13012 WESTMORELAND FARM RD

SOIL/SITE EVALUATION
for ON-SITE WASTEWATER SYSTEM

Re: Application for improvement permit for Westmoreland Farm Road, Lot 24
Health Department file no. 2792B

Based on the criteria set out in Title 15A, Subchapter 18A, of the North Carolina Administrative Code, Rules .1940 through .1948, the evaluation indicated that the site is **UNSUITABLE for** a ground adsorption sewage system. Therefore, your request for an improvement permit is **DENIED.** A copy of the site evaluation is enclosed. The site is unsuitable based on the following:

PROPOSED PLOT PLAN

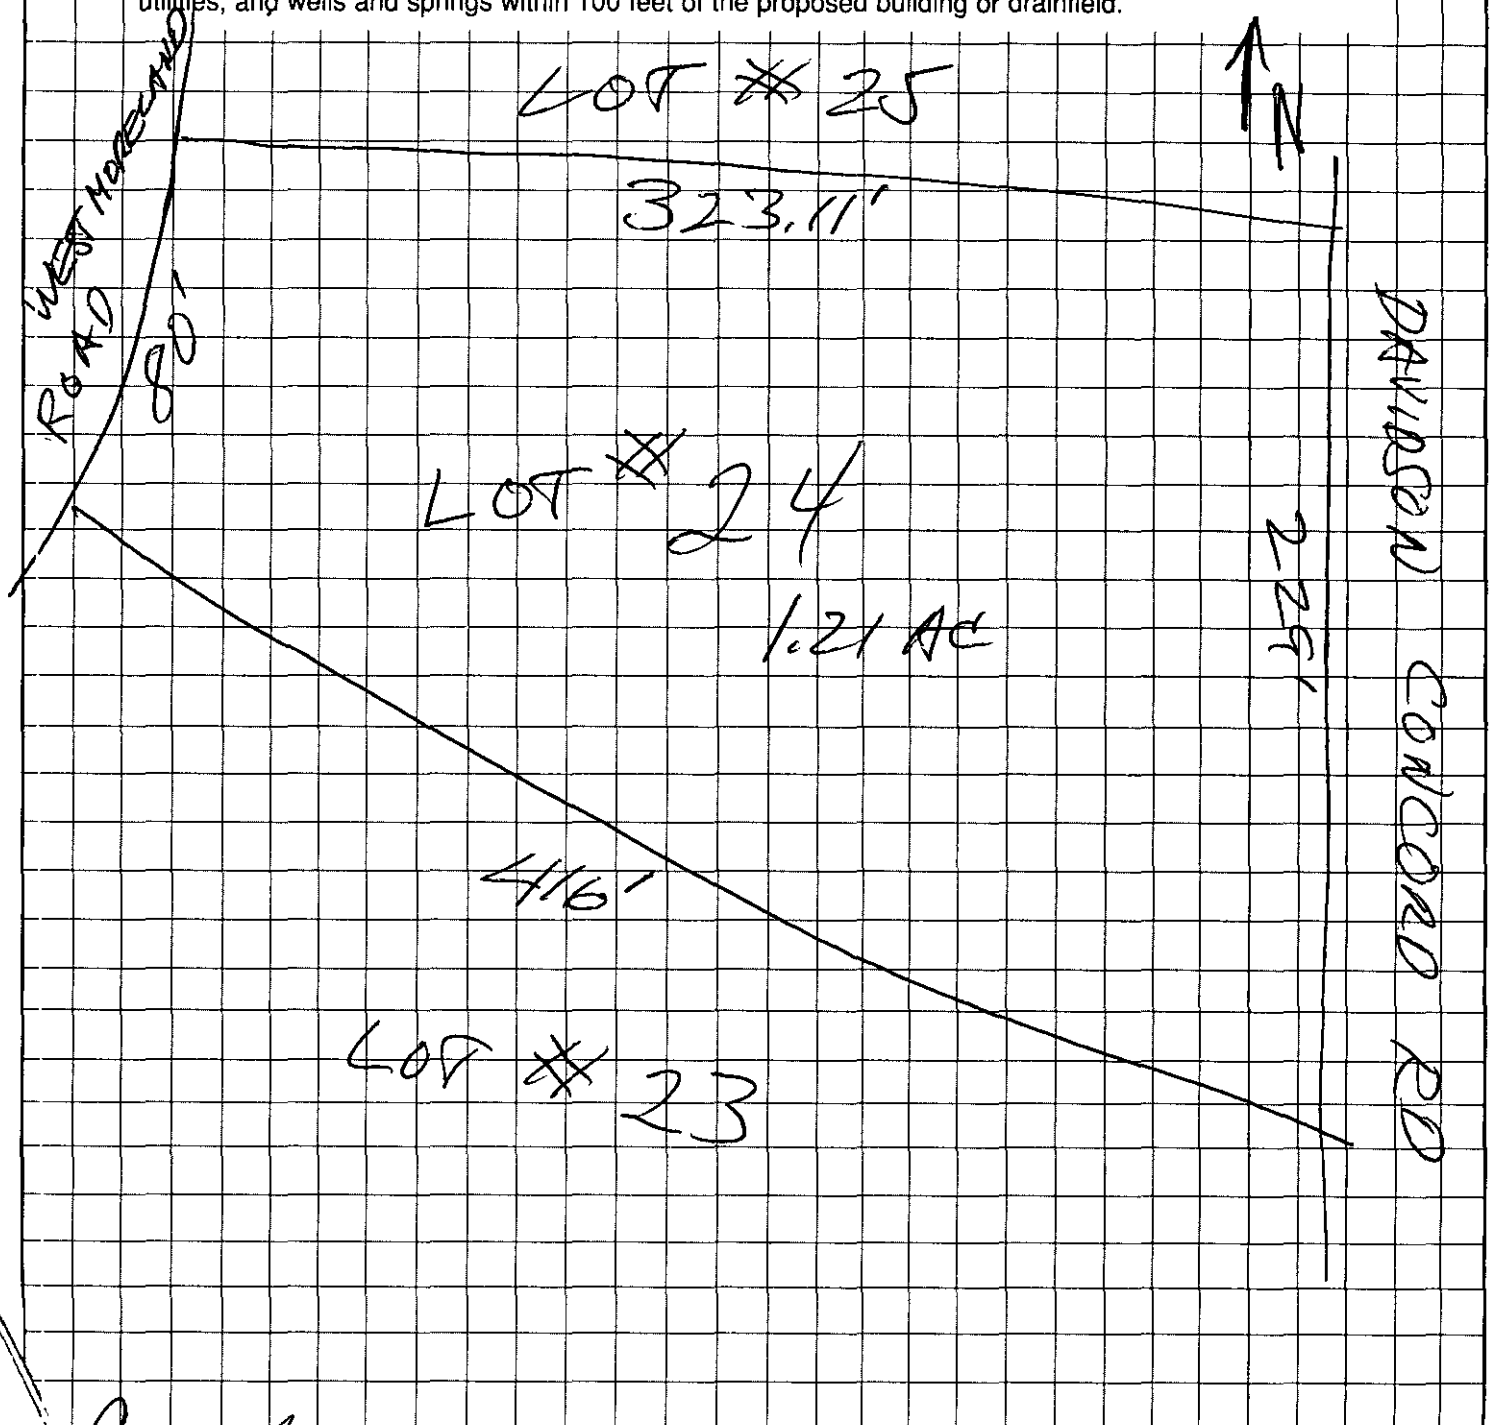
_____Unsuitable soil topography and/or landscape position (Rule .1940)
____X____Unsuitable soil characteristics (structure or clay mineralogy) (Rule .1941)
_____ ____Unsuitable soil wetness condition (Rule .1942)
_____ ____Unsuitable soil depth (Rule .1943)
_____Presence of restrictive horizon (Rule .1944)
____X ____Insufficient space for septic system and repair area (Rule .1945)
_____Unsuitable for meeting required setbacks (Rule .1950)
_____Other (Rule .1946)

However, the site classified as **UNSUITABLE** may be classified as **PROVISIONALLY SUITABLE** *if* written documentation is provided that meets the requirements of Rule .1948(d). A copy of this rule is enclosed. You may hire a consultant to assist you if you wish to try to develop a plan under which your site could be reclassified as **PROVISIONALLY SUITABLE.**
